ARCHITECTURAL REVIEW COMMISSION

3. Design review of a proposed three-story, 204-room, dual-branded hotel, with guest amenities including an outdoor patio and dining area, meeting space, fitness room, breakfast area, bar, and onsite parking. The proposed hotel would be approximately 125,200 square feet with a maximum height of 45 feet for occupied buildings and 52 feet for non-occupied space. The project includes a request for an exception to standard loading space requirements (one space requested where three spaces is the standard), an exception to an Airport Area Specific Plan standard to exceed 40% lot frontage side parking, and exceptions to sign standards to allow for seven wall signs (where four is the standard) and placement of wall signs at the third story, where the uppermost point of the second story is the standard height. An Initial Study/Mitigated Negative Declaration is proposed for adoption. **Project address: 950 & 990 Aero Dr.; Case#: USE-0294-2019 and ARCH-0165-2020; Zone: BP-SP (Airport Area Specific Plan); Sunsmi, LLC, owner/applicant.**

ARCHITECTURAL REVIEW COMMISSION REPORT**FROM:** Shawna Scott, Senior Planner**PROJECT ADDRESS:** 950 & 990 Aero Dr.**FILE NU

EAST ELEVATION

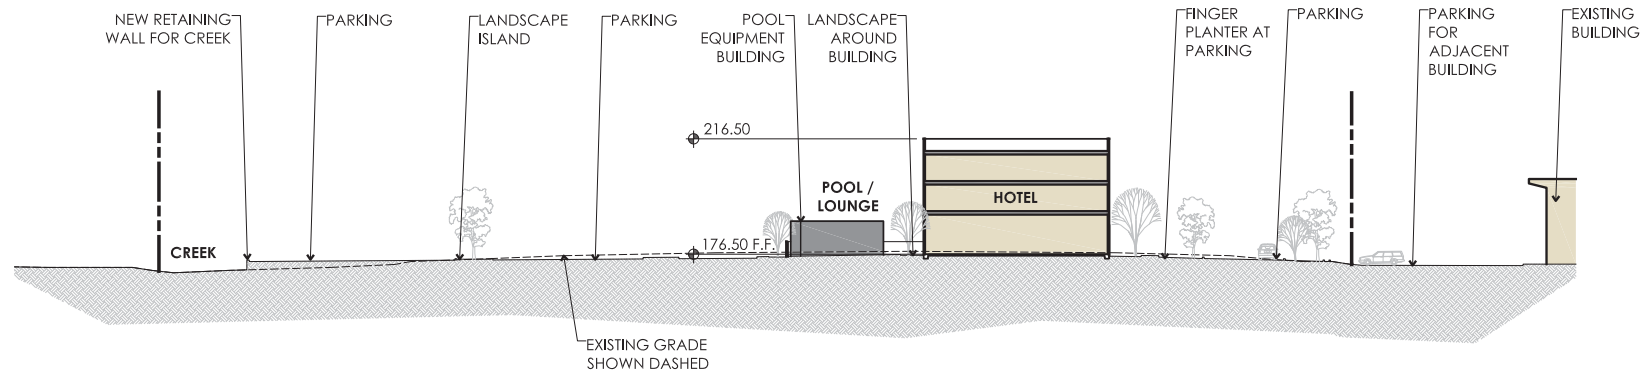
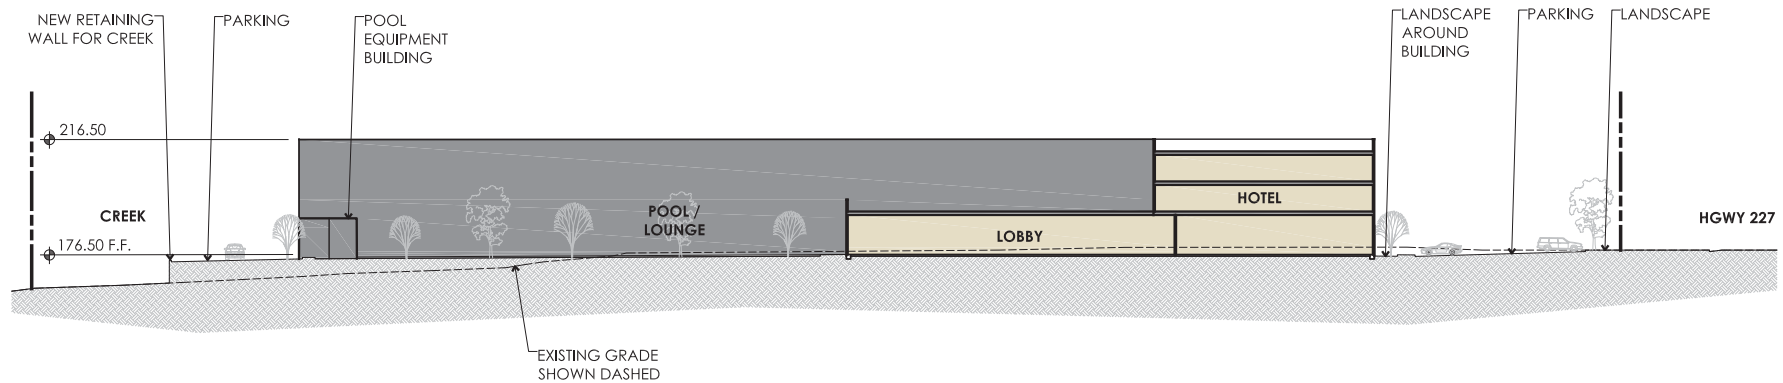
- Consider pedestrian access to the site, especially from the northern corner of the site near the Broad Street sidewalk, and access to SLO Brew/The Rock to the north.
- Consider replacing the sine wave corrugated metal with metal that is similar to the other metal siding on the building, and perhaps a different color.
